NUMBER: 18-101-22

This bulletin supersedes Technical Service Bulletin (TSB) 18-010-21 REV. B, date of issue June 25, 2021, which should be removed from your files. All revisions are highlighted with **asterisks**** and includes updated notes and inspection section.**

Flash: Powertrain Control Module (PCM) Updates

2019	(DJ)	RAM 2500 Pickup
2019	(D2)	RAM 3500 Pickup

Fig. 1
CP3.3 Design Pump

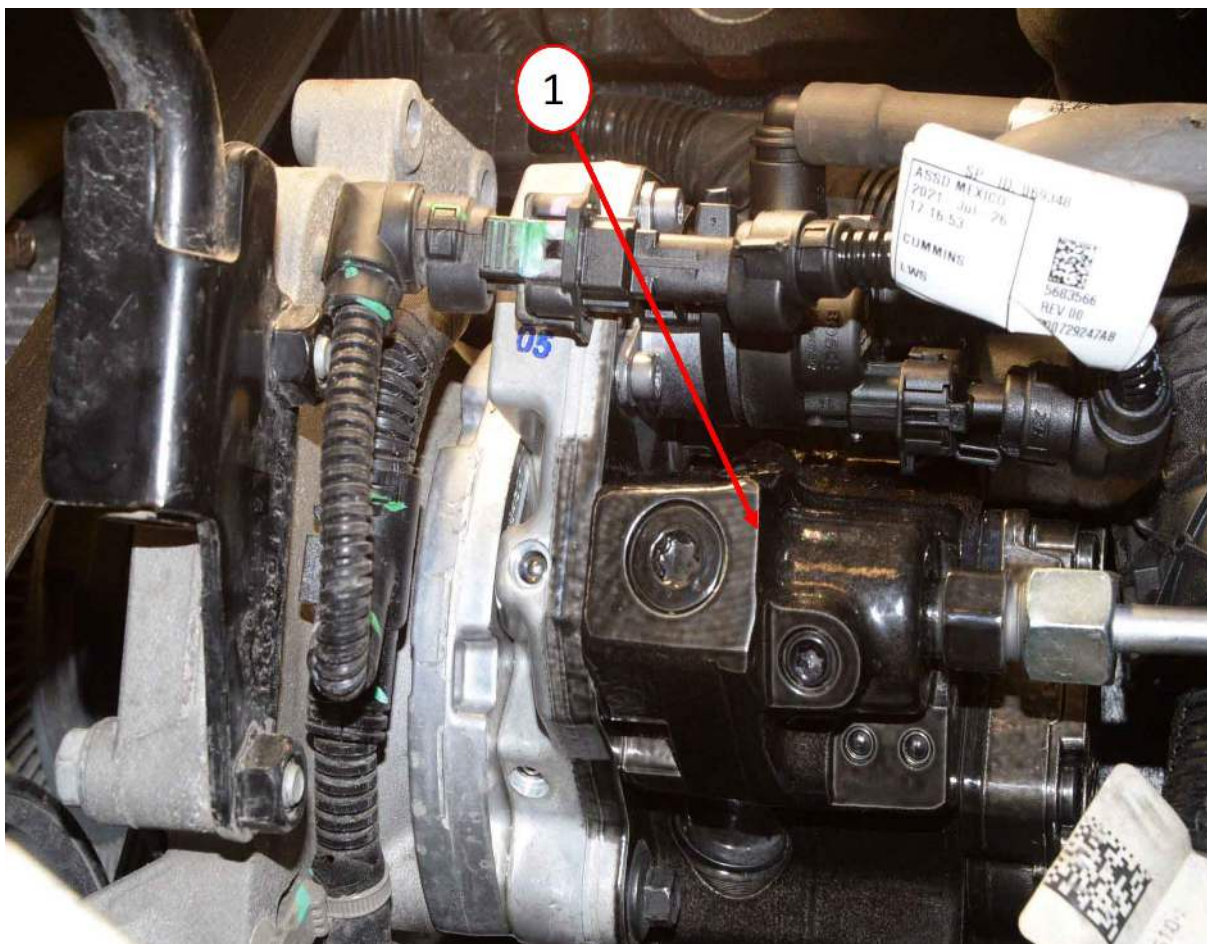
NOTE: **The only calibration available will be for the updated CP3.3 design High-Pressure Fuel Injection Pump ([Fig. 1](#)) . Please ensure that recall Y78 has been completed first before proceeding with this update.

1. Inspect the High-Pressure Fuel Injection Pump to see which pump is currently installed on the vehicle ([Fig. 1](#)) . Also review the vehicle VIP report to see if campaign Y78 has been performed.

2. Does the VIP report indicate that Y78 has been performed, and is the vehicle equipped with the new design fuel injection pump released under the campaign?
 - YES>>> Proceed to [Step 1](#).
 - NO>>> Perform the Y78 campaign first. Once the campaign is performed, new pump installed and PCM updated, the PCM will have all of the updates listed in this document. This Bulletin does not apply.**
